Staff Summary Report

Development Review Commission Date: 10/09/07

SUBJECT: Hold a public meeting for a Development Plan Review for RESIDENCE INN / CITY HALL PARKING GARAGE located at 117 East 5th Street.

DOCUMENT NAME: DRCr_Hotel-CityGarage_100907

1 GROUND FLOOR PLAN
 A1 SCALE: 1/16"=1'-0"

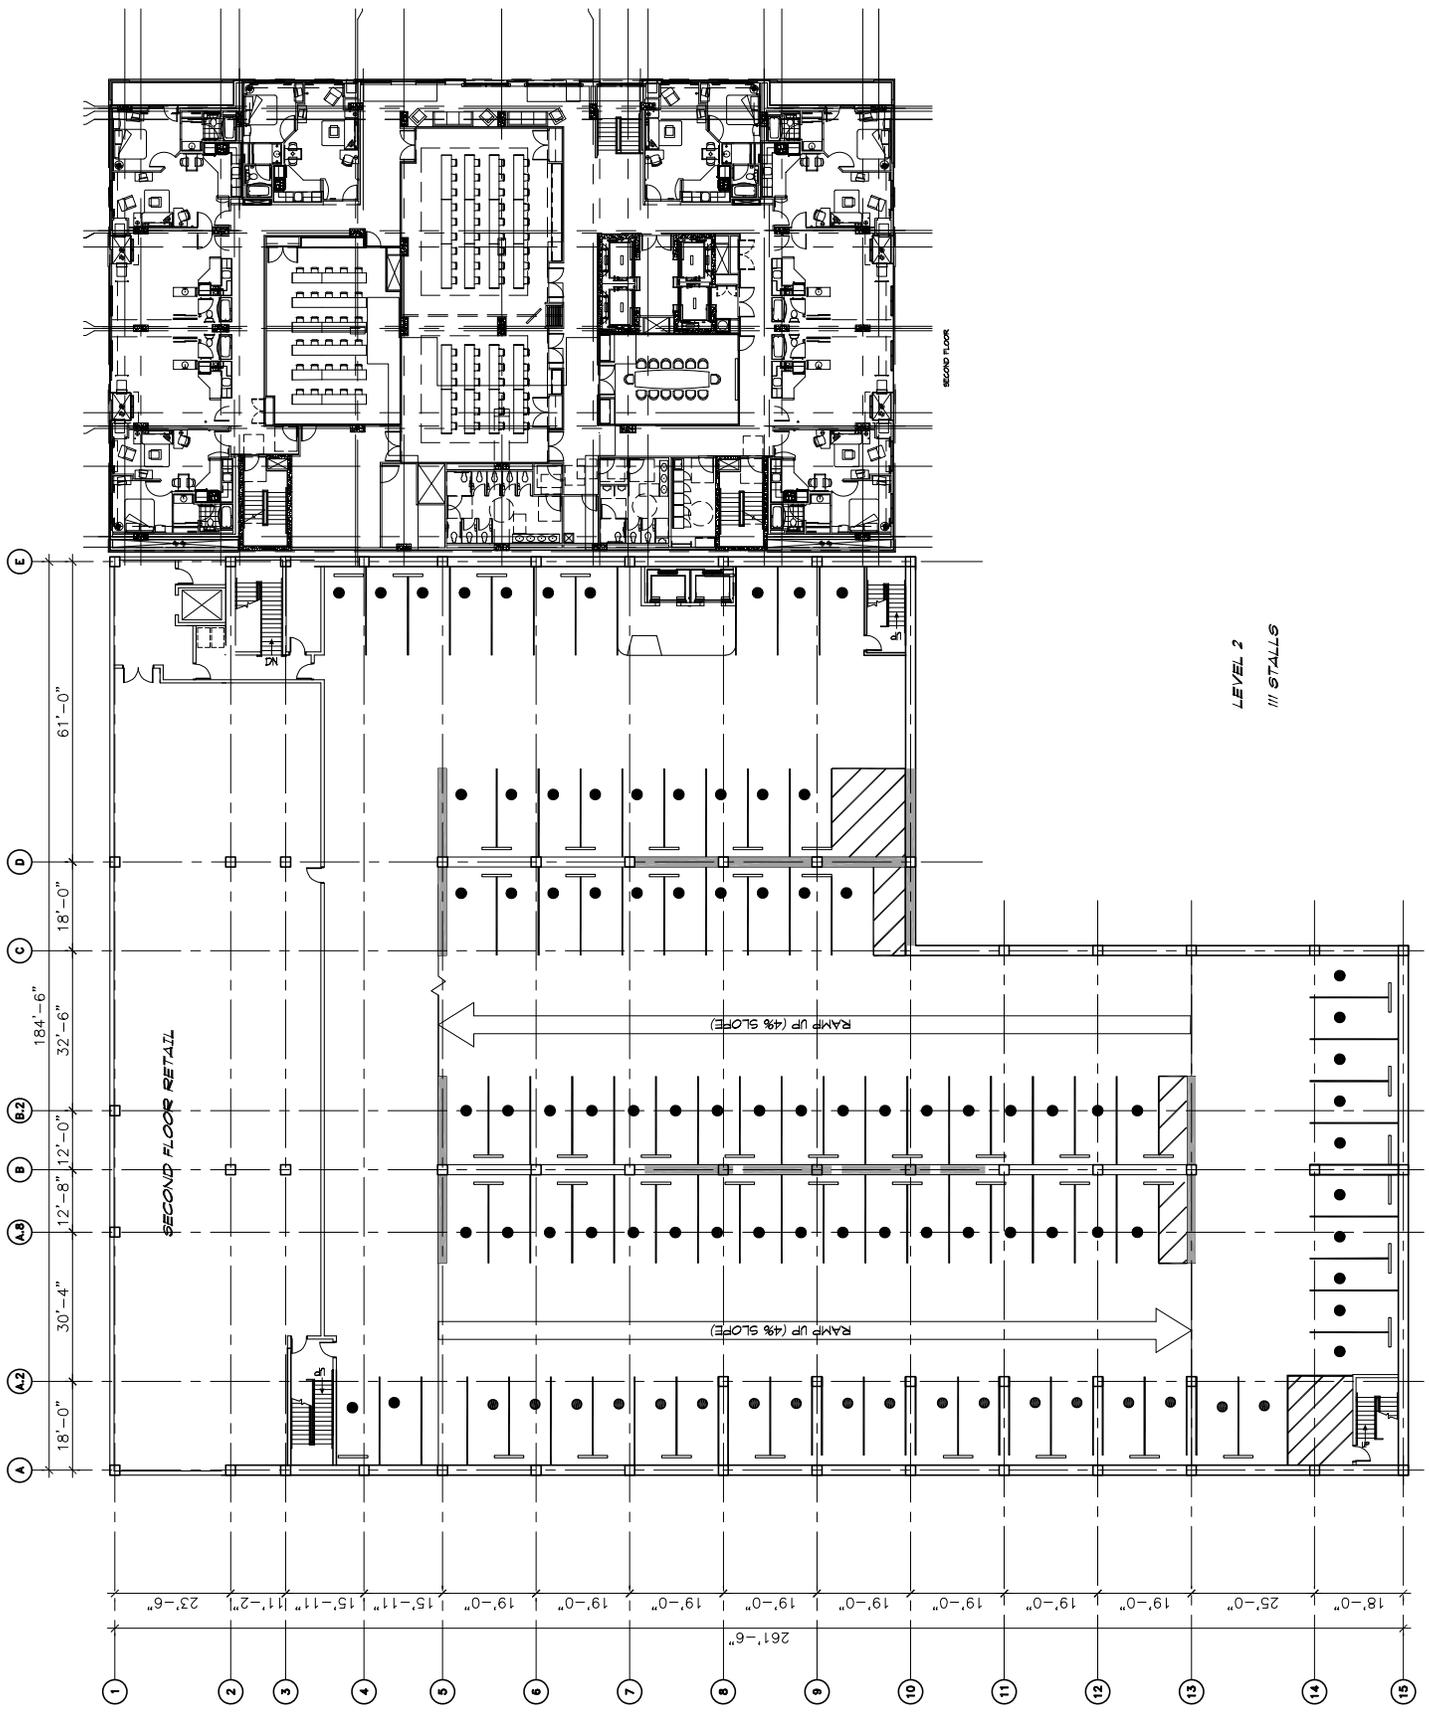
8. To facilitate protection of hotel patrons, retail / office users and the public, provide full vehicular and pedestrian access control to the garage. Locate the line of control at the arm gate location indicated on the ground floor plan. Do not provide access control across the fire lane that passes under the garage. Provide details of steel mesh partitions and gate control.

9. Provide a glazed, air conditioned elevator vestibule at the ground floor of the garage adjacent to the hotel lobby entrance.
10. At southwest stair ground level exit, move exit from west elevation to south elevation to coordinate with landscape plan. Provide pathway from this exit to the public right of way on 6th Street.

11. At southeast stair second, third, fourth and fifth levels, do not provide an exit-way through a parking space; delete the adjacent parking space.
12. At northwest stair fourth level, do the following:

LEVEL 4
97 STALLS

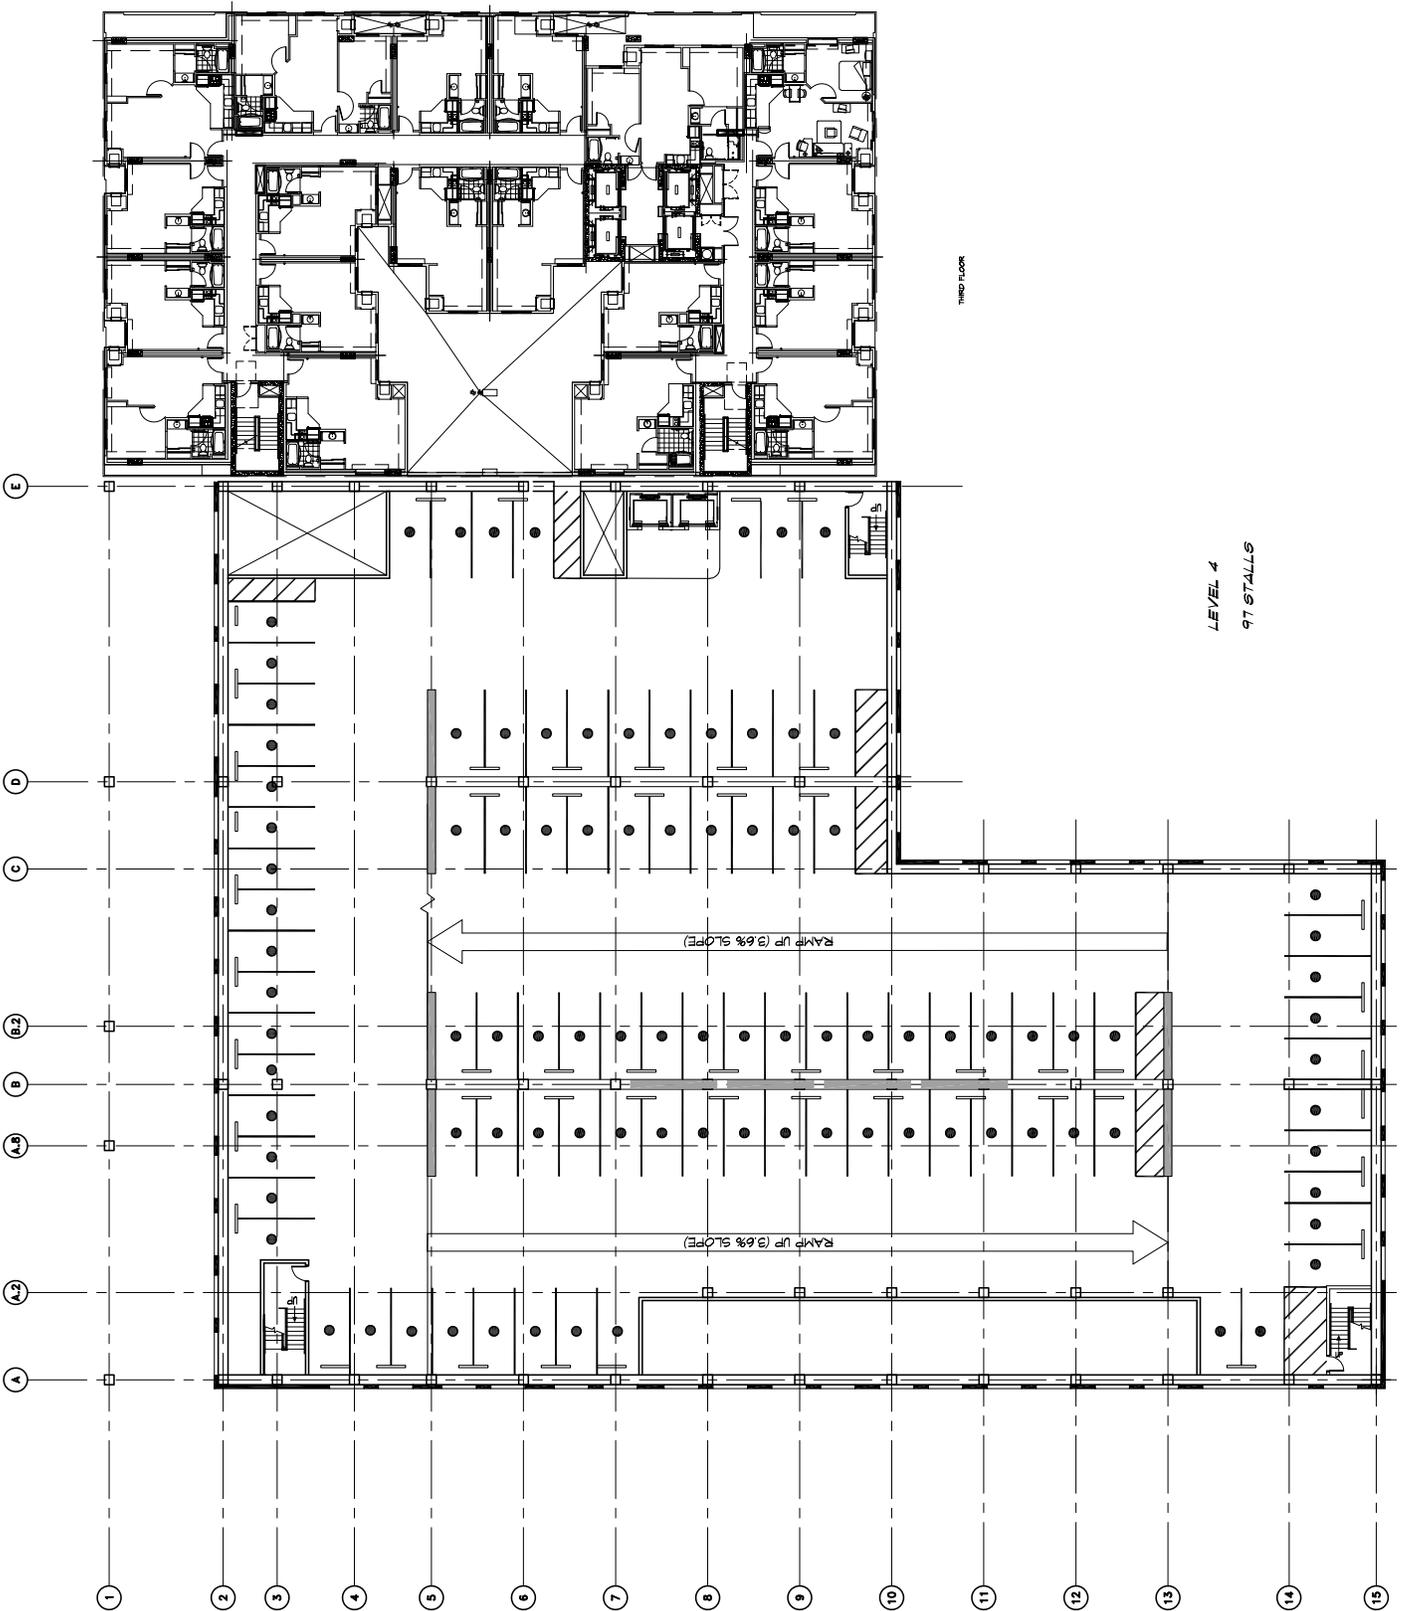
- a. The stair core is out of position on the fourth level plan with respect to this stair on the third and fifth levels. Specifically, the stair on the fourth level is indicated partially north of grid line 3. Correct this inconsistency on the fourth level and remove one parking space south of this stair to accommodate the change.

- b. Provide access control for the area north of this stair enclosure similar to as indicated on the third and fifth levels.
13. At south parking row second, third and fourth levels, delete narrow parking space in this row; only nine parking spaces fit in this row.

14. At north parking row fourth level, provide row configuration similar to the third level that respects placement of structural columns. Delete one parking space from this row on the fourth level to accommodate the columns.
